I hereby certify that I have inspected the as-constructed facility and that, with the following exceptions, the as-constructed facility is in substantial conformance with the approved grading and drainage plan with engineer's stamp dated 9/29/95 and revision date of 10/18/95:

FRANK D. LOVELADY, P.E. 300 ALAMOSA ROAD N.W. ALBUQUERQUE, N.M. 87107 (505) 345-2267		GRADING AND DRAINAGE PLAN OFFICE / WAREHOUSE COMPLEX FOR ALL-AMERICAN FOAM	
Designed: F.D.L.	Drawn: STAFF	Checked: F.D.L.	Scale: 1" = 20'
Date: 9/95		Job No. 500

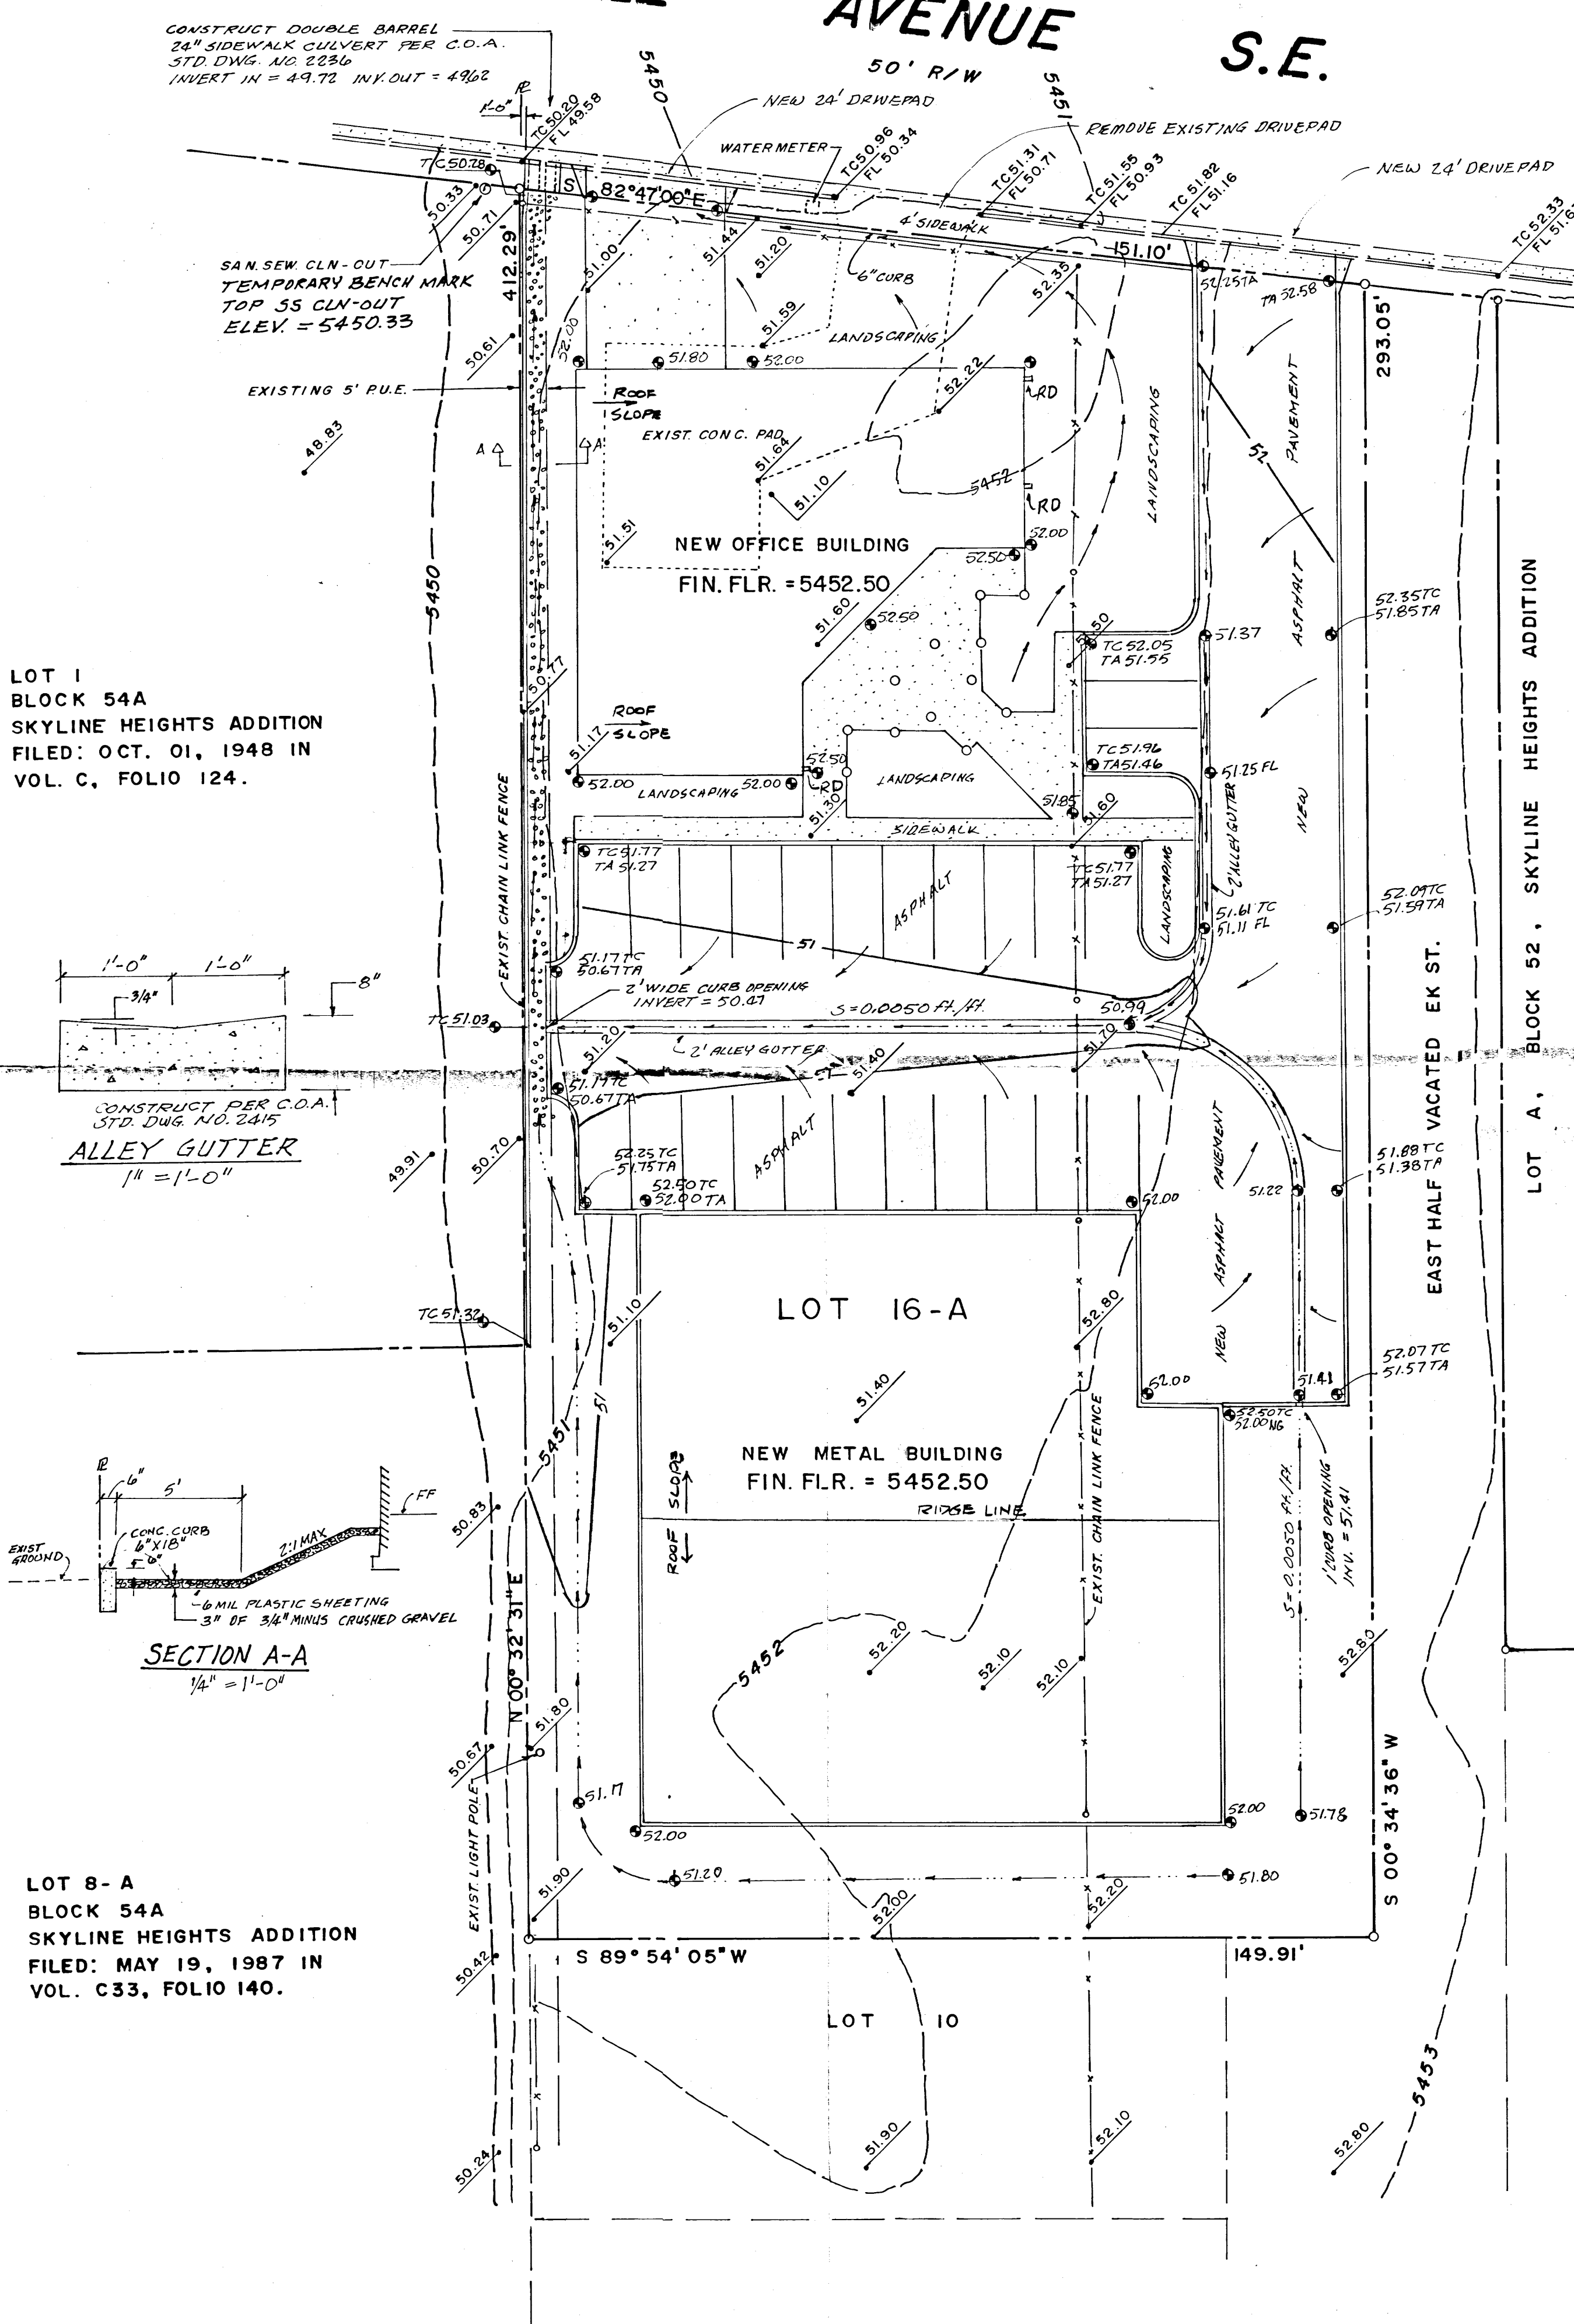
- Only a single 24" sidewalk culvert was constructed rather than a double 24" sidewalk culvert as shown on the plan.
- The channel, Section A-A, has not been constructed as originally shown on the approved plan.
- The swale around the NE corner of the building to convey runoff to the driveway has not been constructed as shown on the plan.

A 30-day temporary Certificate of Occupancy is requested to permit the owner to occupy the building at this time and have time to complete the drainage improvements as per plan. As the facilities now function, there is no possibility of runoff from the site entering the property to the west.
